ADDENDUM No. 1

PROJECT MANAGEMENT - PUBLIC SERVICES - CITY OF ANN ARBOR  
GEDES AVENUE IMPROVEMENTS  
PROJECT DETAILS  
INFILTRATION DETAILS

PROJECT MANAGEMENT - PUBLIC SERVICES - CITY OF ANN ARBOR  
GEDDES AVENUE IMPROVEMENTS  
GEDDES AVENUE TYPICAL SECTIONS  
P.O.B. TO 23+75

PROJECT MANAGEMENT - PUBLIC SERVICES - CITY OF ANN ARBOR  
 GEDES AVENUE IMPROVEMENTS  
 SCALE PLAN: 1"=20' PROFILE: 1"=4'  
 DRAWING No. STM-03  
 SHEET No.

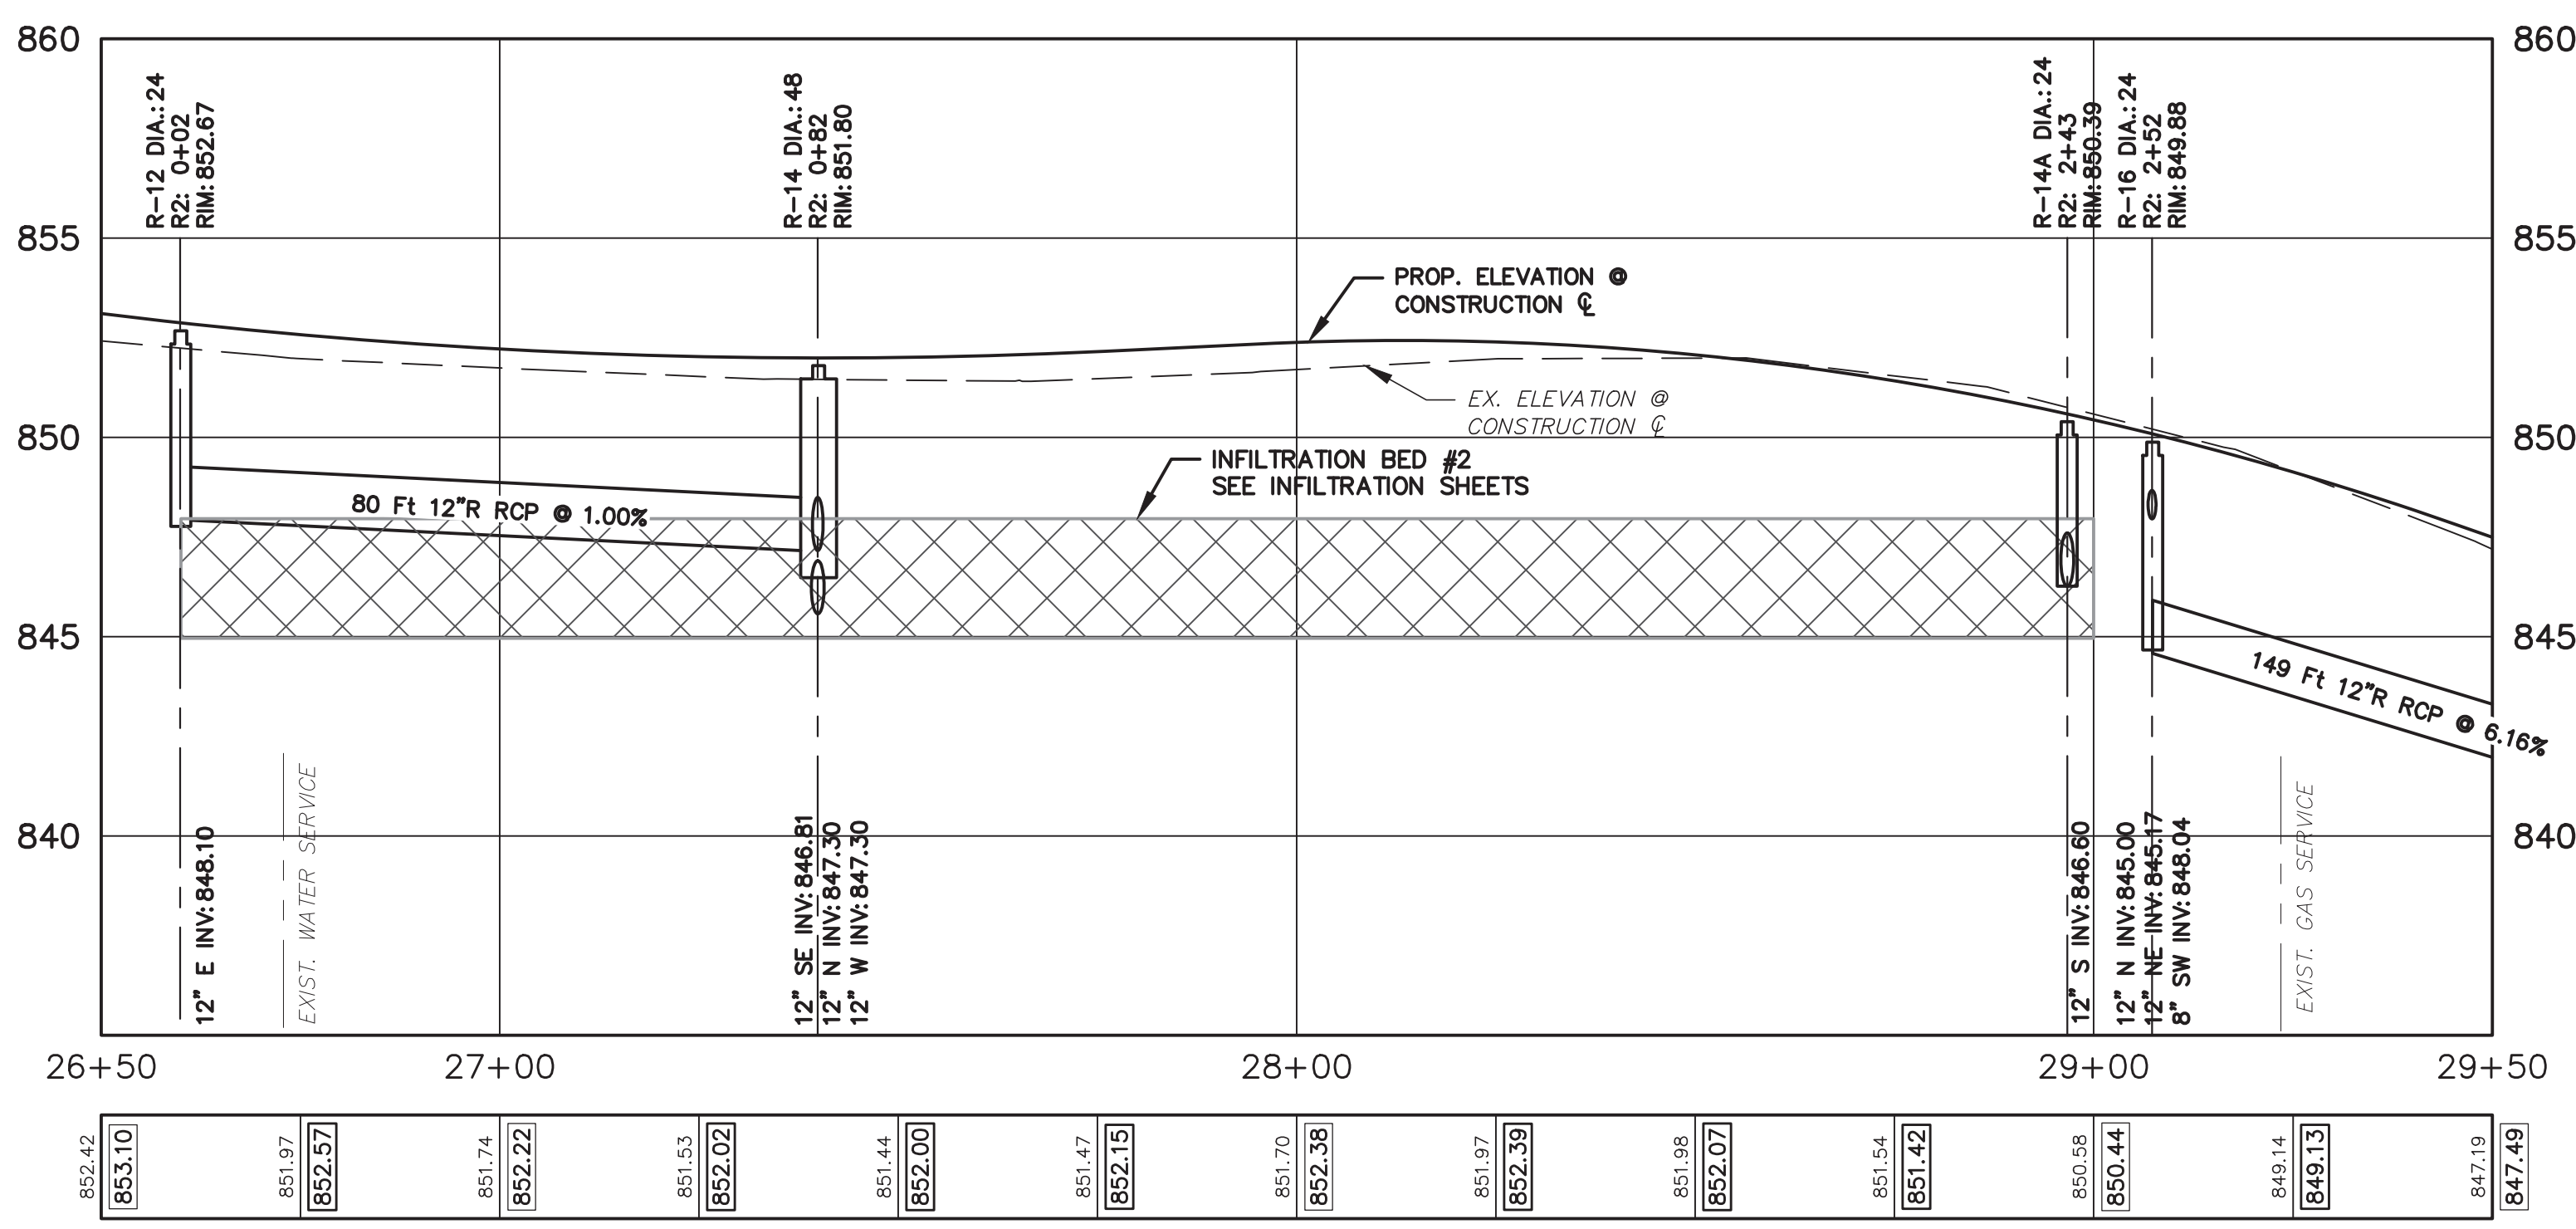
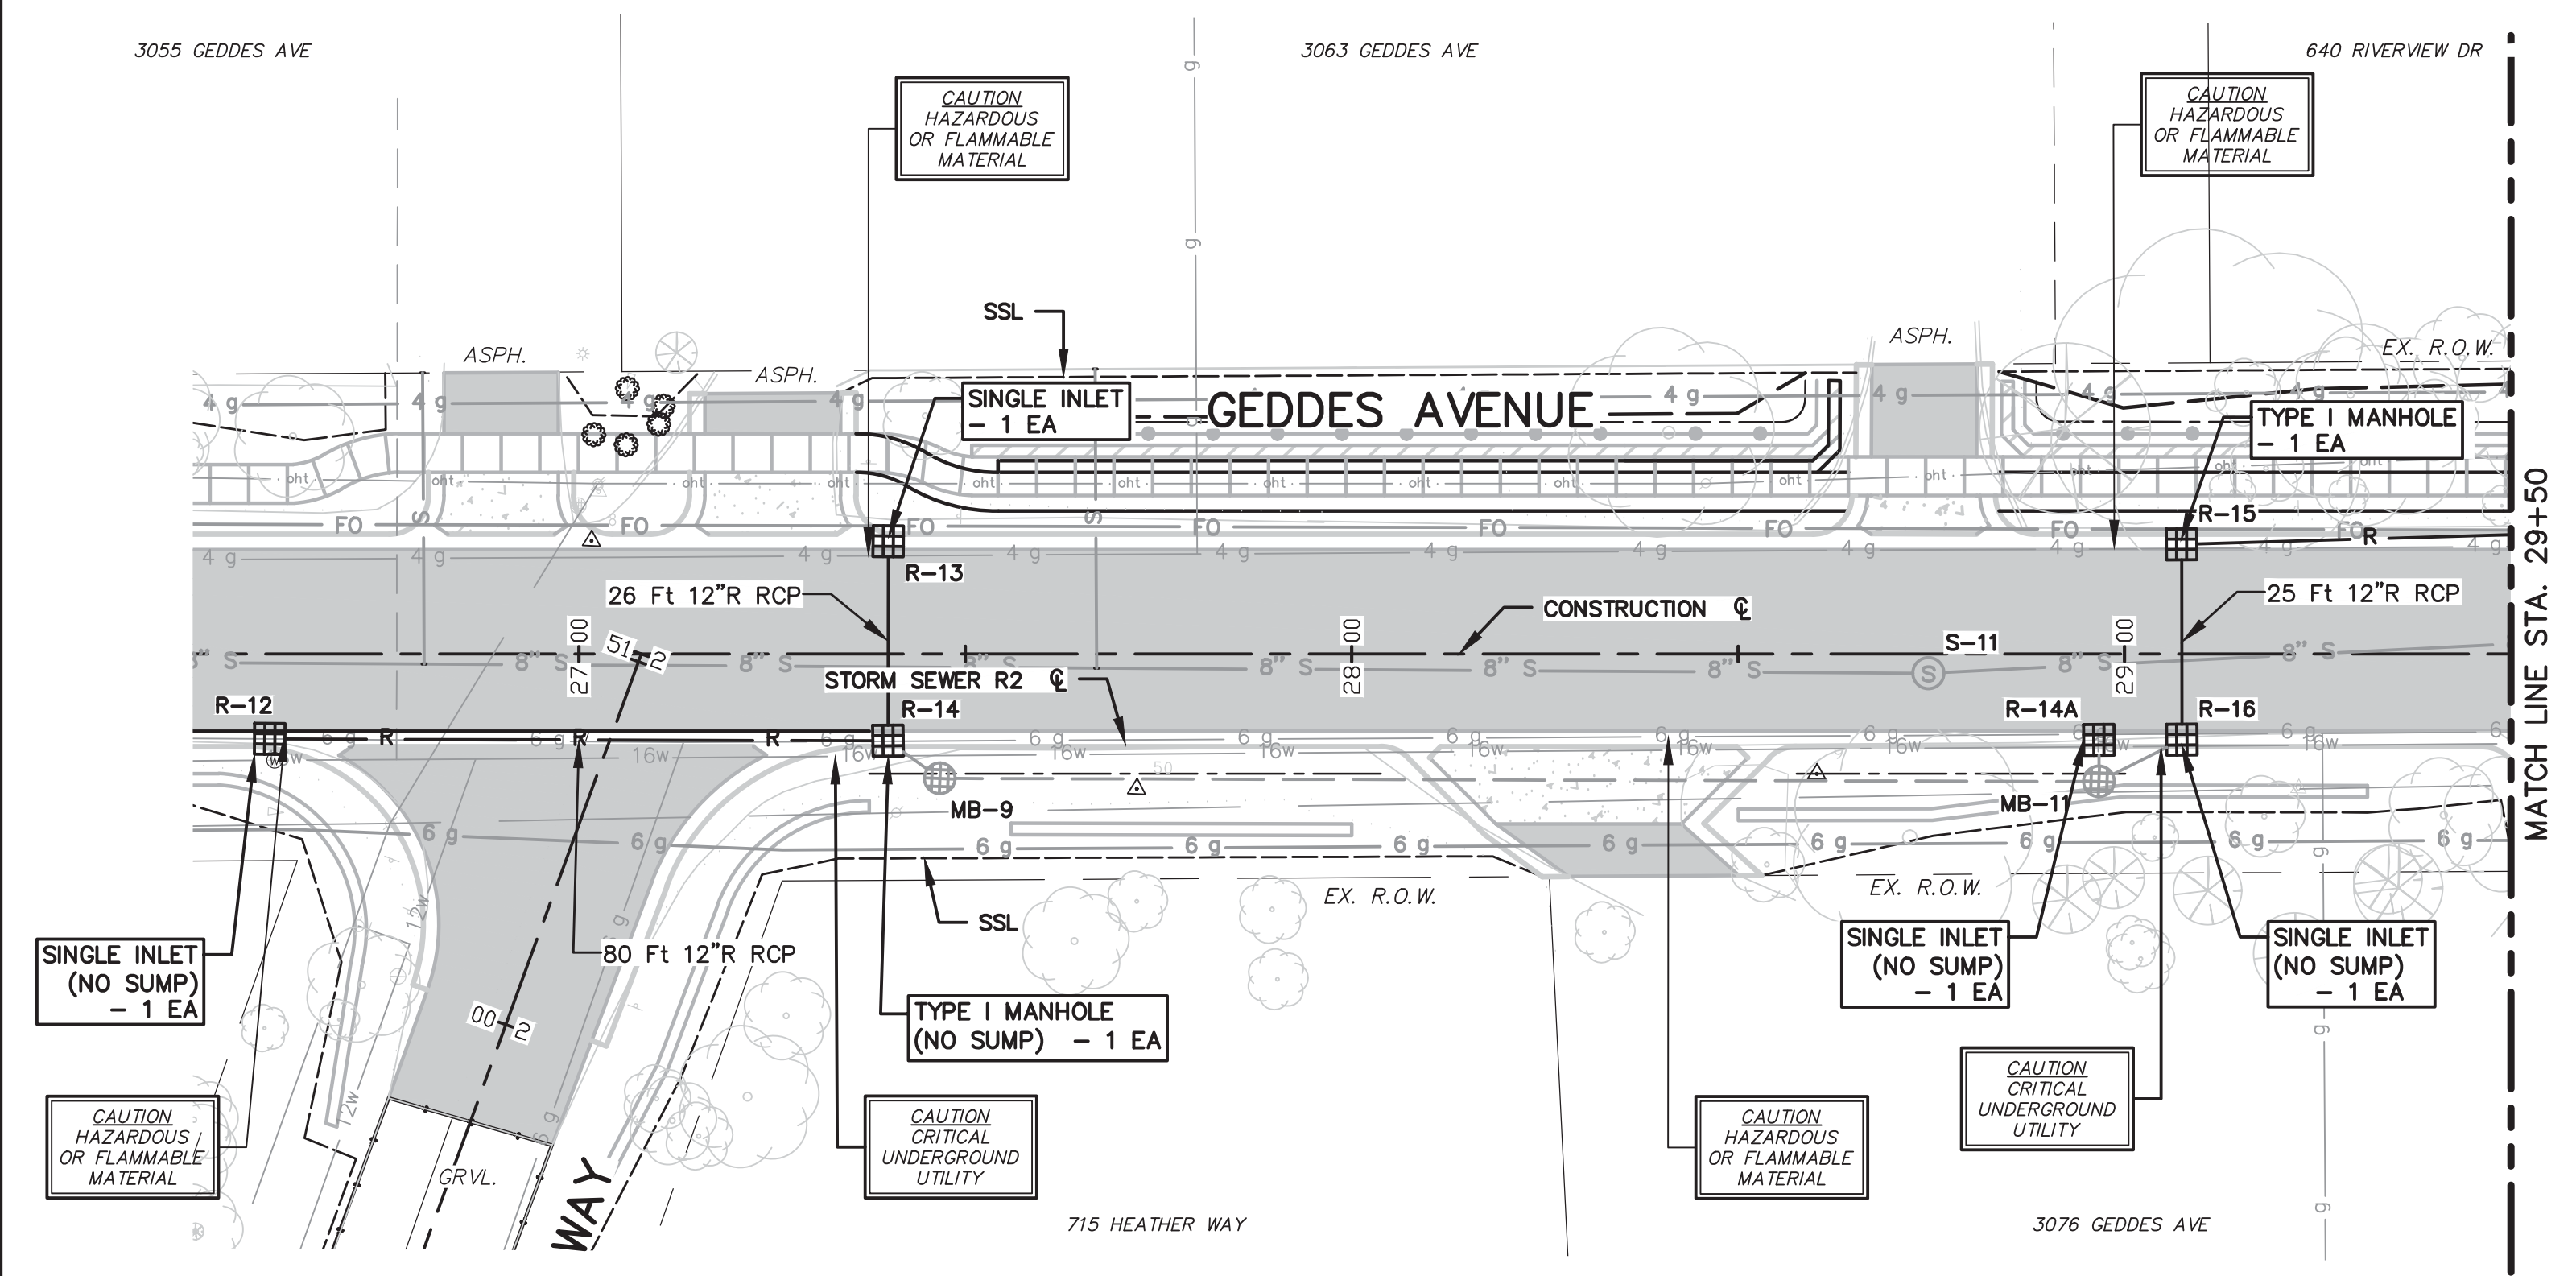
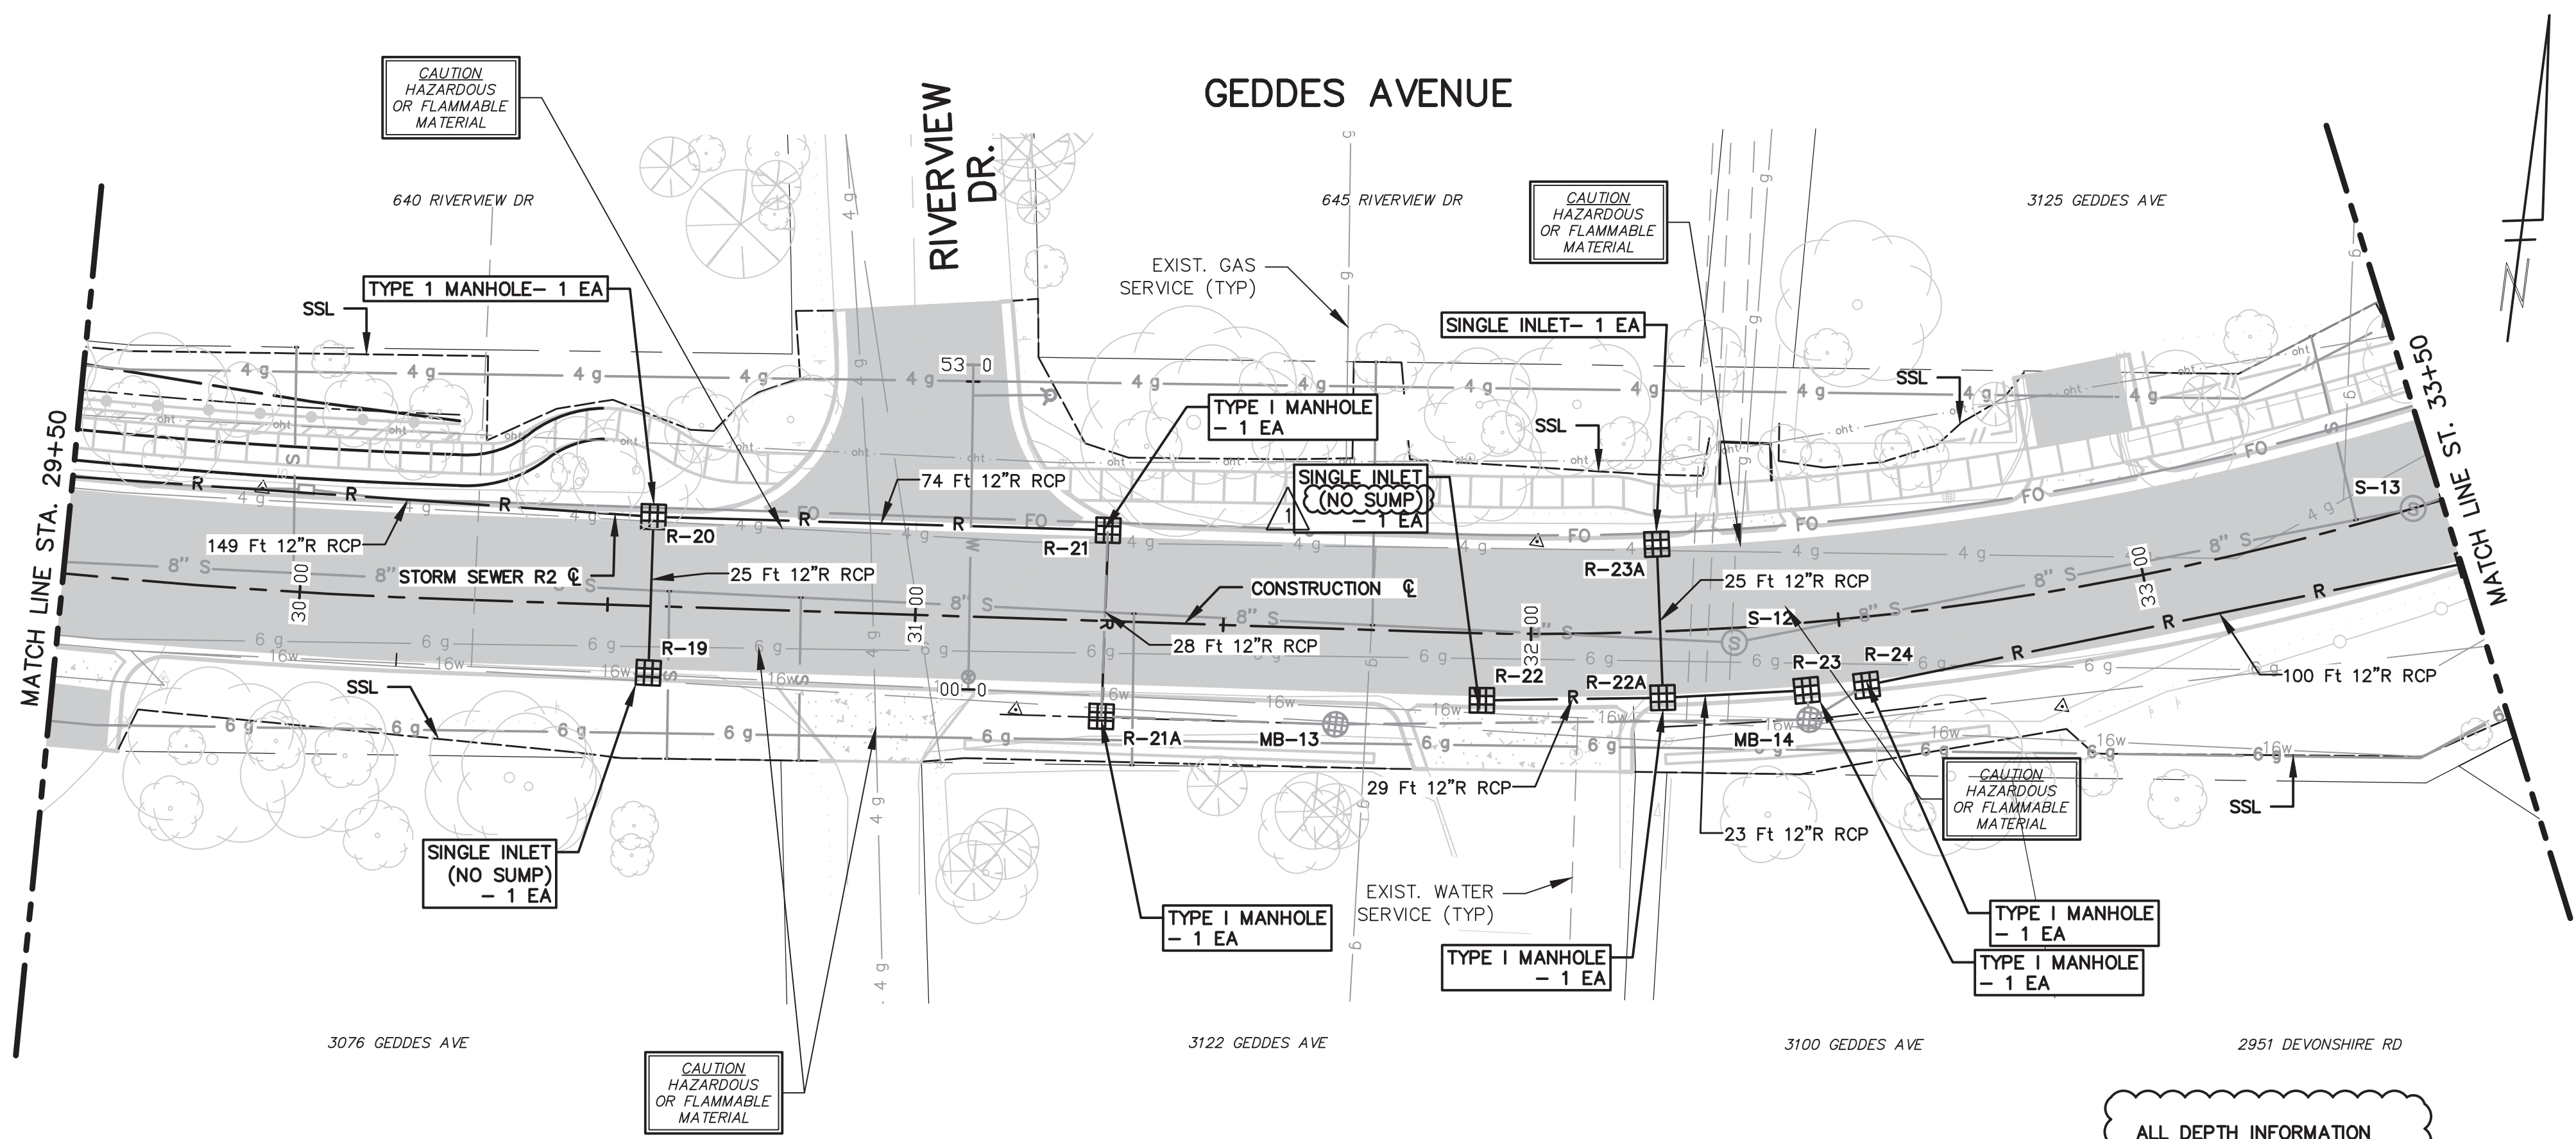
ALL DEPTH INFORMATION HAS BEEN UPDATED IN THE STORM SEWER STRUCTURE TABLE. STRUCTURES NOT REQUIRING A SUMP HAVE BEEN IDENTIFIED. R-14A AND R-16 HAVE BEEN LISTED AS INLETS IN THE TABLE.
